Preliminary Consultation
MONTGOMERY COUNTY HISTORIC PRESERVATION COMMISSION
STAFF REPORT

Address:	25321 Frederick Road, Clarksburg	Meeting Date:	2/25/2026
Resource:	Master Plan Site #10/57 David Zeigler House	Report Date:	2/18/2026
Applicant:	Montgomery Parks (Catherine Stratton Treadway, Agent)	Public Notice:	2/11/2026
Review:	Preliminary Consultation	Staff:	Laura DiPasquale
Proposal:	Stabilization of frame main block, and demolition and reconstruction of log building section with fenestration modifications and dormer construction

The applicant proposes to demolish the log portion of the house and reconstruct it to its current appearance with some modifications, including modified windowsill heights, removal of non-historic chimneys, and construction of a large, shed dormer centered on the rear roof slope. The applicant also proposes to stabilize the main frame block of the house and to replace existing windows and roofing.

Figure 4: Existing/demo southeast elevation drawing (above) and proposed elevation drawing (below).

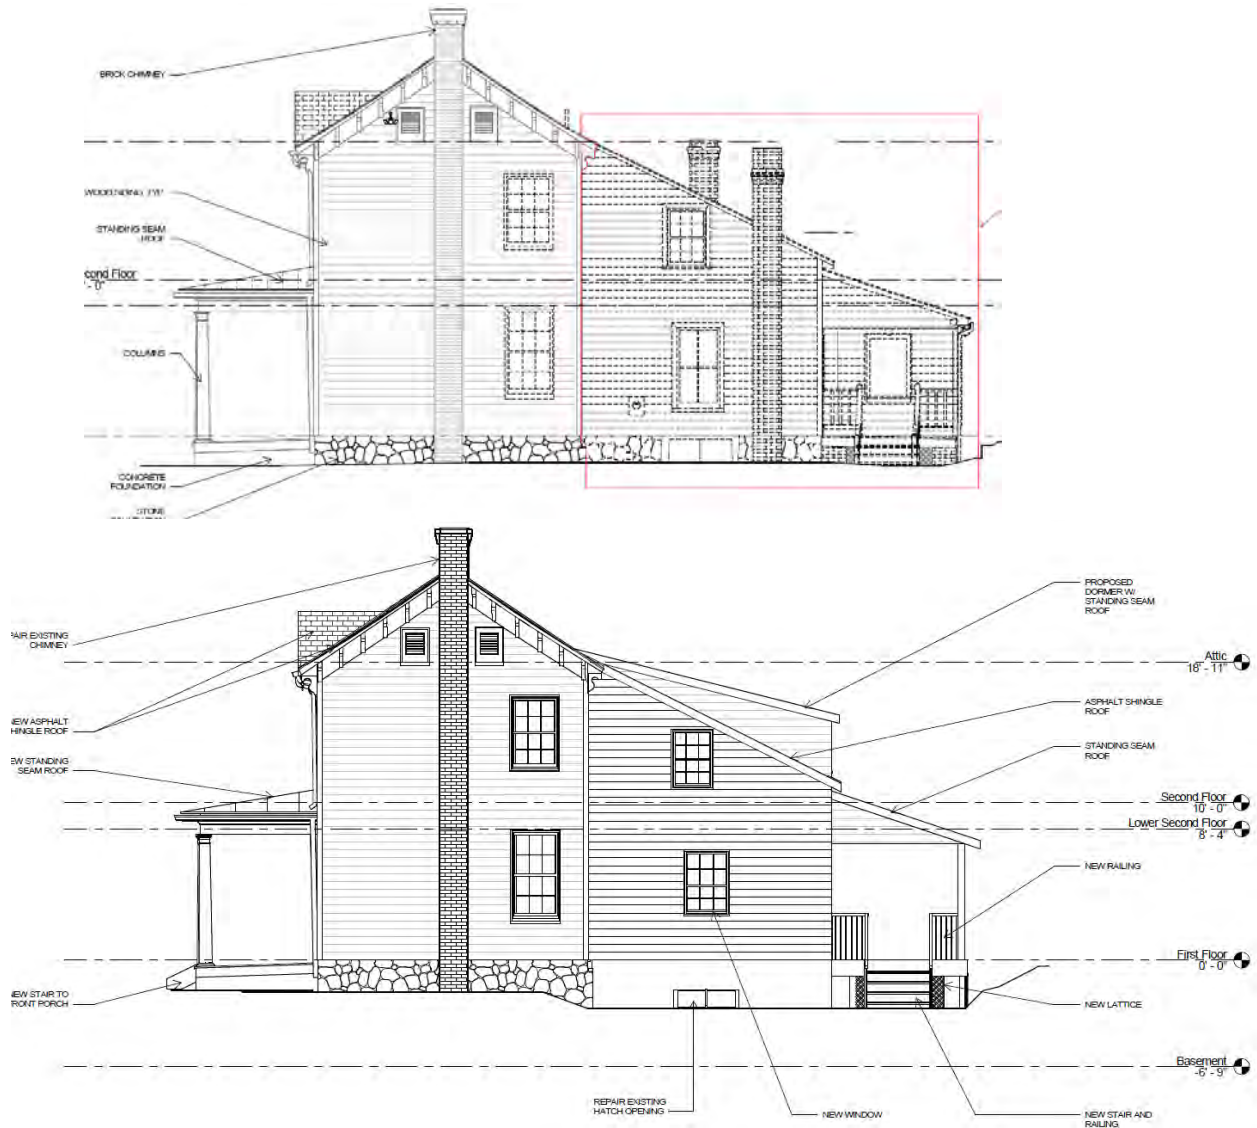
On the southeast side elevation, the new addition would raise the sill of the first-floor window and install a 6-over-6 window instead of a 2-over-2 window. Staff notes that the existing 2-over-2 window would likely have been a later alteration, as larger glazing was more expensive and smaller paned windows were typically used in log structures. Along this elevation, the applicants also propose to eliminate the existing chimney, which staff finds is also a later addition to the structure.

Figure 6: Existing/demo northwest elevation drawing (above) and proposed elevation drawing (below).

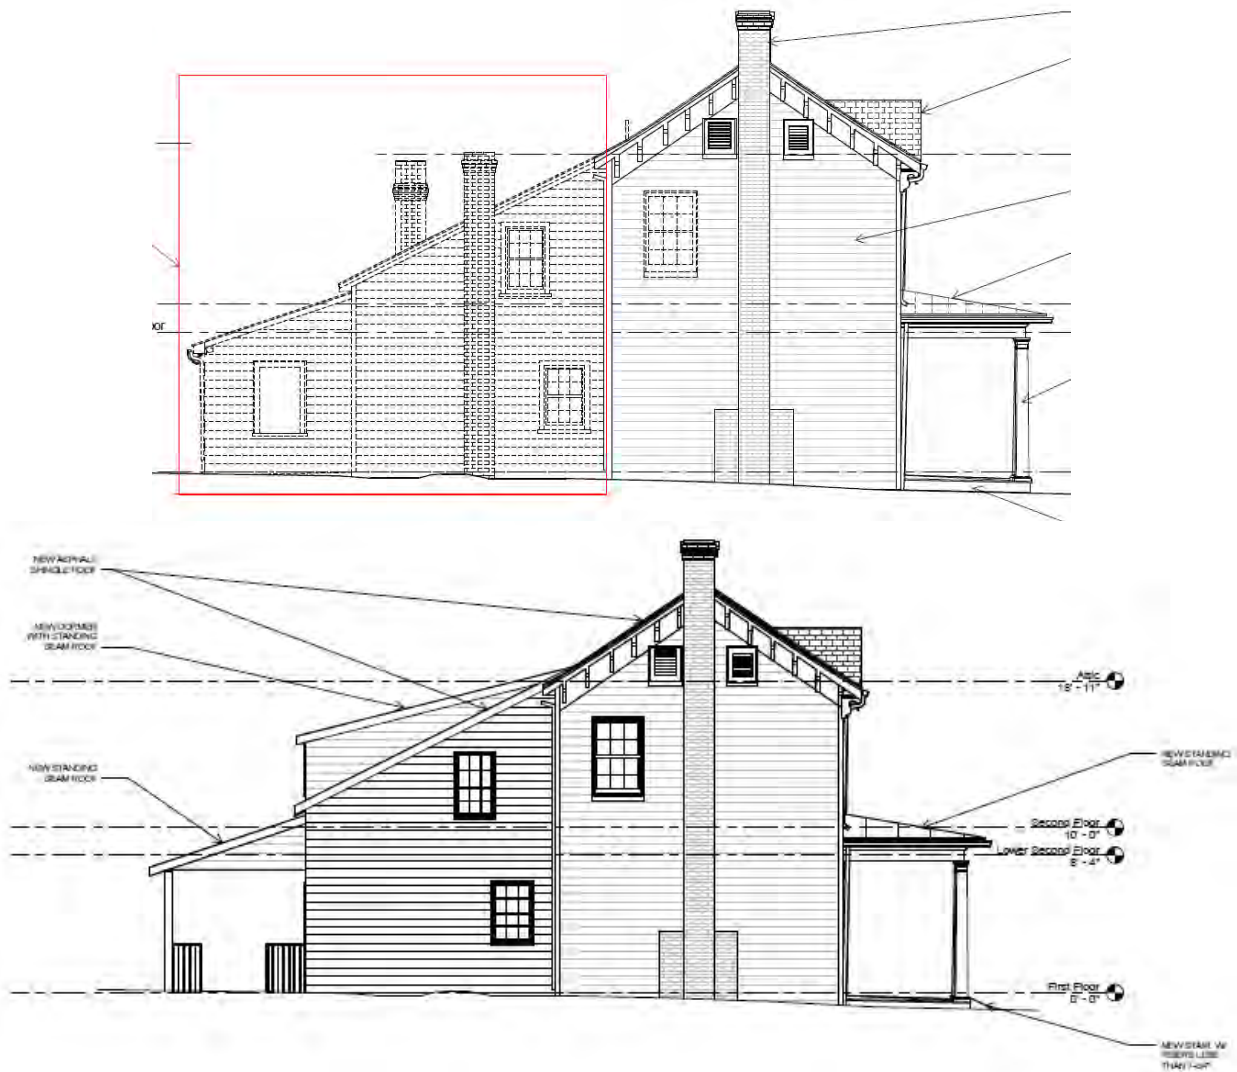
On the northwest side elevation, the applicants also propose to eliminate the non-original chimney, and to eliminate siding infill on the rear porch.

Figure 8: Existing/demo rear elevation drawing (above) and proposed elevation drawing (below).

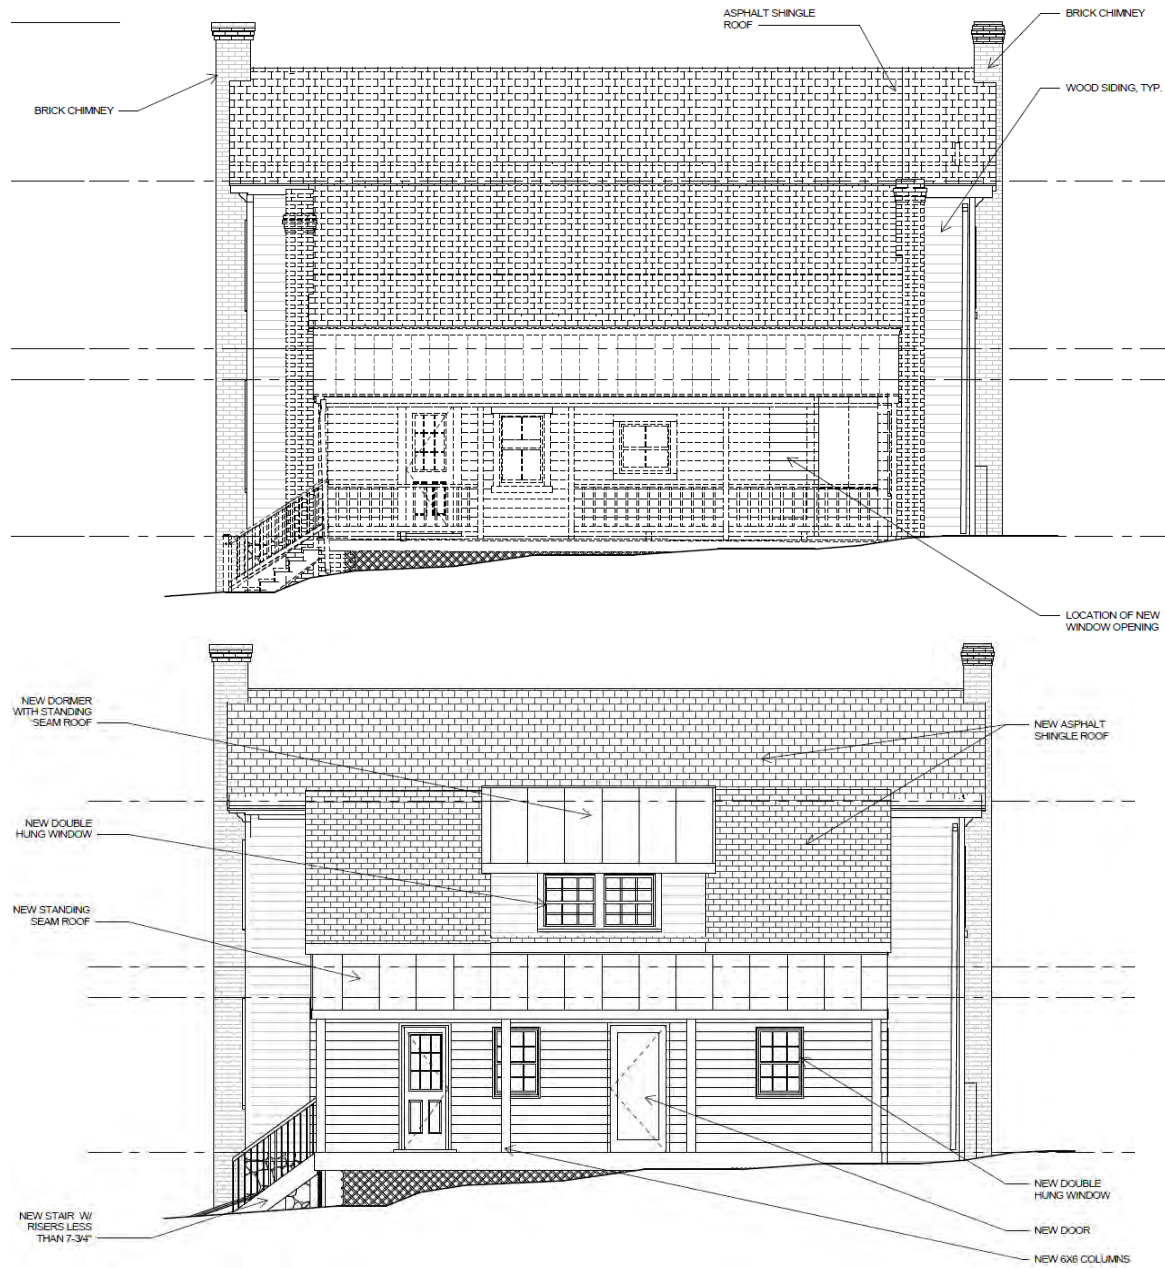
On the rear elevation, the applicants propose to reconstruct the existing roofline, but with a central 12-ft 7-inch wide shed roof dormer. The dormer would have a standing-seam metal roof, while the reconstructed roof slope would be clad in asphalt shingles.
